HARTING Product Change Notification

PCN/18/006/C+N

Title: Minor change of DIN rail outlet for RJ45 Keystone jacks - External

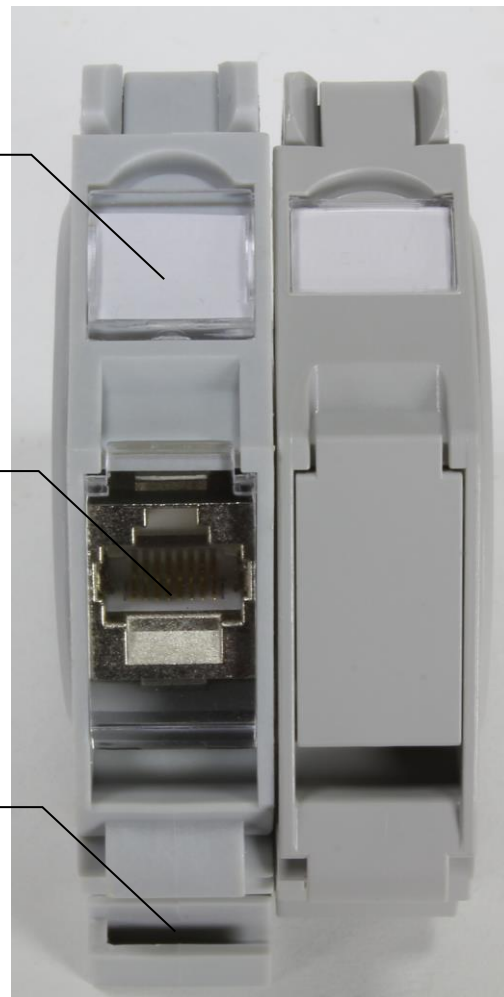
The plastic molding tools needed to be replaced and we use this task to improve some points of the DIN rail outlet design. See picture with the details below.

NEW: Bigger marking area

NEW: Transparent cover

NEW: Improved unlocking area

New desing

Old design

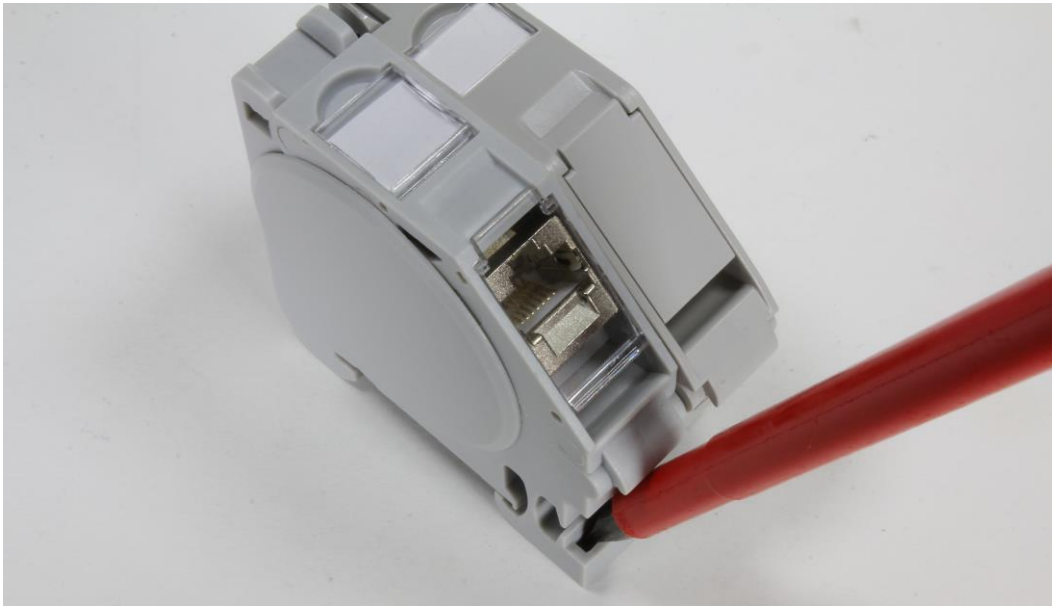
At this picture the improved unlocking area is shown in function with a screw driver to remove the DIN rail outlets from the DIN rail more easily compared to the old design.
